#### Staff Report Z-21-22-2 Alta Dove Valley PUD

April 7, 2023

Proposed Use: Multifamily residential

Building Elevations date stamped March 28, 2023 (2 pages)

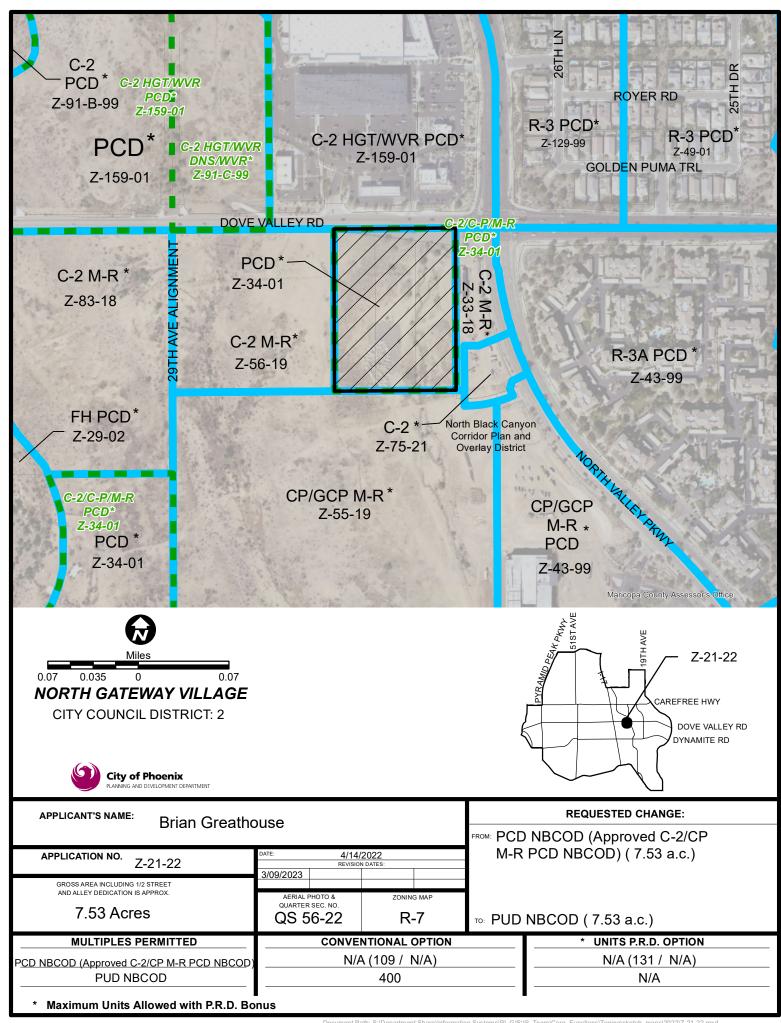
Staff recommends that the applicant add a requirement in the PUD Design Guidelines to only permit an average maximum of 60 percent of stucco material for the exterior perimeter elevations in order to further enforce high-quality architecture. This will be calculated by adding the percentages of stucco on each side of the building together and dividing it by the number of sides of the building to obtain the percentage average, not to exceed 60 percent. This is addressed in Stipulation No. 1.f.

Staff also recommends that exposed areas of the parking garage be fully screened using an architectural decorative screening that is both functional and aesthetically pleasing. This is addressed in Stipulation No. 1.g.

- f. Pages 14-15, Design Guidelines, Exterior Materials: Add "The exterior perimeter building elevations shall be finished with an average maximum of 60% stucco material".

- g. Page 15, Design Guidelines, Exterior Materials, 3rd paragraph (Exposed areas of the parking garage walls...): Replace the third paragraph as follows:

- Exposed areas of the parking garage walls shall be decoratively screened with metal trellises, architectural metal panels and extrusions, translucent glazing, decorative lighting, and/or other architectural screening materials that will add texture, depth, shadow lines, create visual interest for pedestrians, and enhance the public right of way.
